Consolidated Clause in Works Committee Report 6, which was considered by City Council on June 14, 15 and 16, 2005.

**Morningside Avenue/Markham By-Pass Extension
Individual Project Environmental Assessment Study
Status Report (Ward 42 - Scarborough Rouge River)**

Purpose:

Attachment 5 : Technically Preferred Alternative

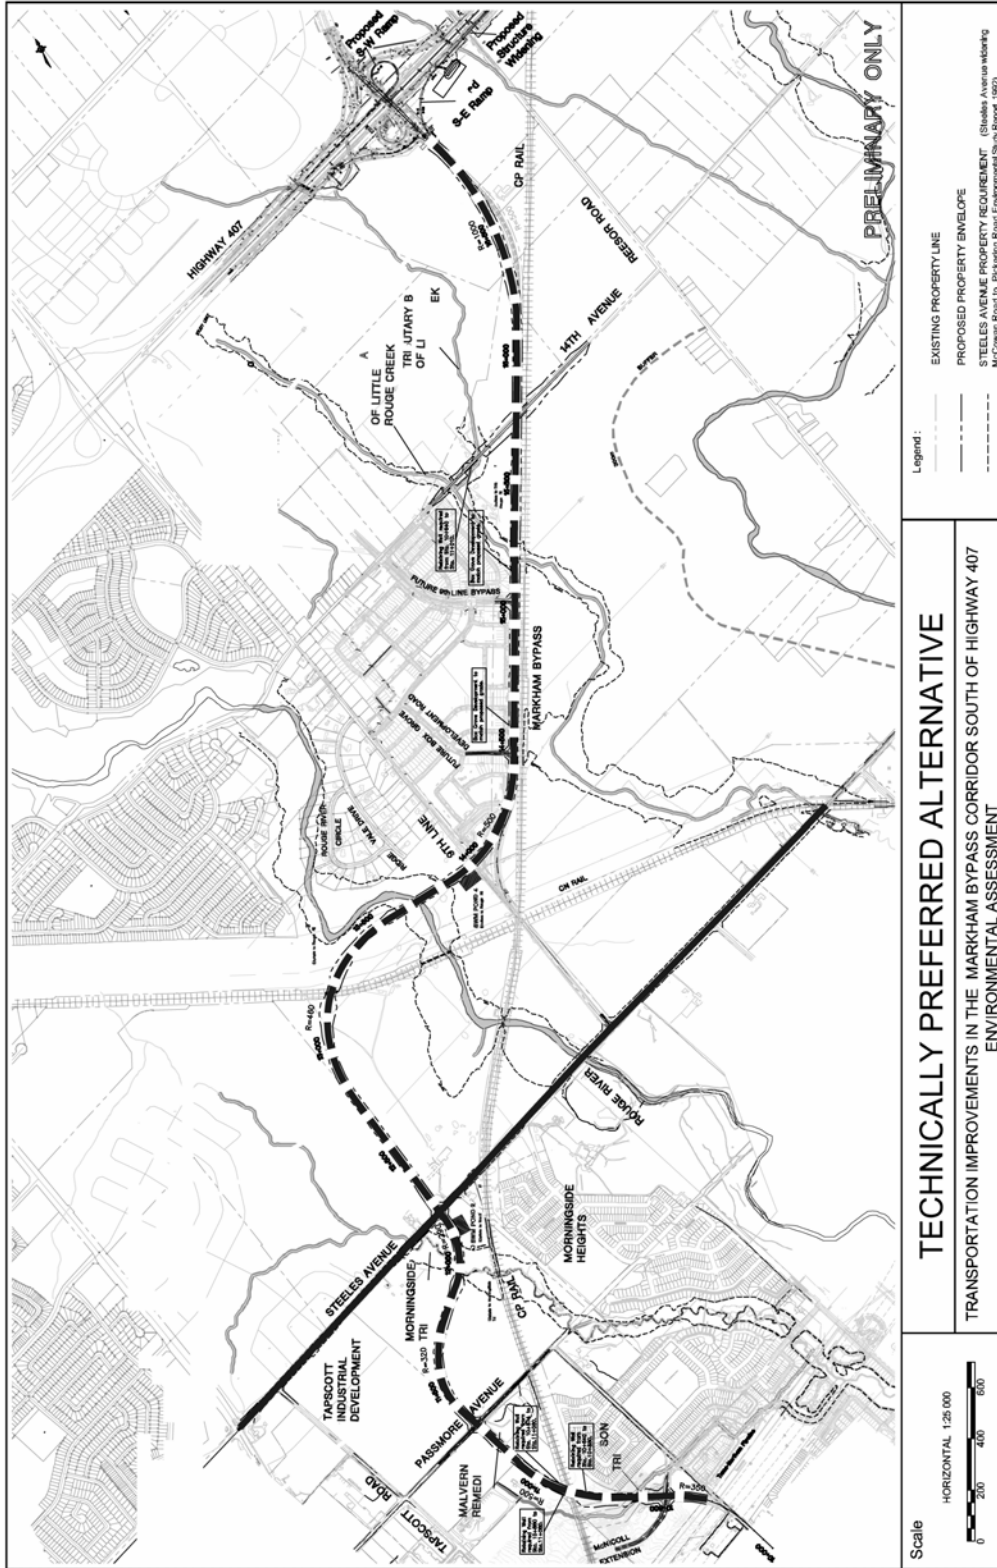
- (1) City Council advise York Region that it strongly opposes and formally objects to the technically preferred alignment for the extension of Morningside Avenue south of Steeles Avenue East, as developed in the Environmental Assessment Study for transportation improvements in the Markham By-pass Corridor south of Highway 407;

The technically preferred alignment being recommended by the Project Team is illustrated on Attachment 5. This high-order arterial road has an 80 km/h design speed and is expected to be posted at 60 or 70 km/h. All horizontal and vertical curves support this design speed. Signalized intersections are expected at existing and planned major roads, but the preferred spacing is at

Accordingly, the City needs to ensure that the chosen alignment will in fact serve those lands well and allow for a good grid of connecting local roads. The technically preferred alignment would permit industrial activity along the rail line. Economic Development staff encourages such activity and hopes that rail freight usage will be provided for, when this and any other alignments are being evaluated. Some industrial operations in the area already make use of private rail sidings for their freight operations.

The technically preferred alignment is very expensive due to the number of river, creek and rail crossings that would be required. York Region's construction cost estimates show the Morningside Avenue Extension component of the technically preferred alternative south of Steeles Avenue coming in at \$26 million excluding property acquisition costs. To date the City has devoted no funding towards this undertaking. Given the inter-regional nature of this alternative and the fact that this would be the eastern connection between Highways 401 and 407 within York Region and the City of Toronto, the Province should be requested to contribute to funding the cost of this road.

The technically preferred alignment places as much of the new road as possible south of Steeles Avenue in the industrial area west of the CPR line. After crossing the CPR, the Morningside Avenue Extension continues at the extreme western edge of the new community where it will serve the planned Business Park as well as collecting residential traffic destined both north and south to employment areas. South of Finch Avenue, the existing Morningside Avenue is bordered by employment uses or the backyards of residential uses, such that the impact of additional traffic would be minimized. However, the technically preferred alignment is not the best for promoting development, and is very costly.

- (2) **City Council request York Region to:**
- (a) **re-evaluate Alignment C north and south of Steeles Avenue East, that being the City's preferred alignment south of Steeles Avenue East, and advise City Council of the implications of maintaining Steeles Avenue at its approved width of four traffic lanes; and**

Attachment 6 : Alignment C

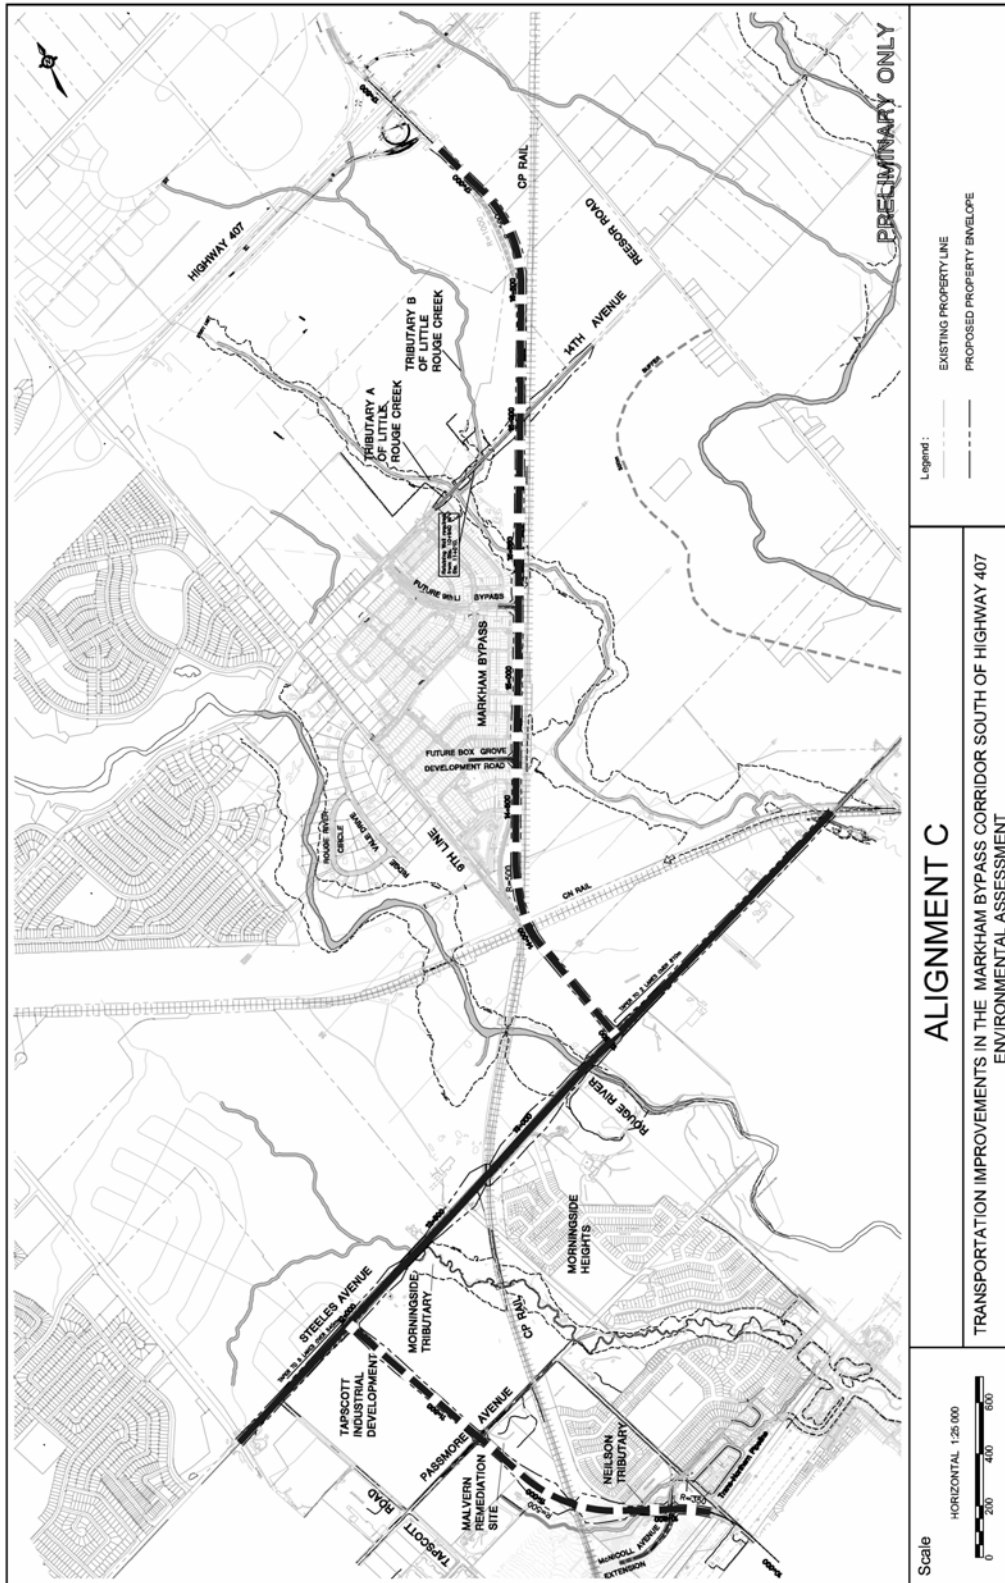
Alternative C and its family of alignments would require a jog along Steeles Avenue. The predicted combined traffic volumes on both roads could only be handled by an eight-lane cross-section, which would be extremely unusual for a municipal road. Although no new water crossing structures would be required, existing bridges and culverts over the watercourses would have to be widened with consequent possible damage to the natural environment. Substantial earthworks would also be required to drive the road through the rolling terrain along Steeles Avenue. A complex multi-level bridge could be required at the “asterisk” where Ninth Line and the two rail lines all cross (see Attachment 2). However, alignment C most closely corresponds to the alignment preferred by the City of Toronto prior to the 1999 Morningside Heights OMB Decision.

The position of Toronto City Council in the past has been that the Morningside Avenue Extension should end at Steeles Avenue, and Alternative C is the closest to achieving that goal. However, under Alignment C Steeles Avenue would have to be widened to eight lanes. To date, Steeles Avenue has been approved for widening to four lanes but the portion within the study area is currently only a two-lane road. Thus, if Alignment C were chosen, the result would be the potential for significant local impacts with no distinct operational advantages. York Region should be requested to evaluate Alignment C with either four or six lanes on Steeles Avenue.
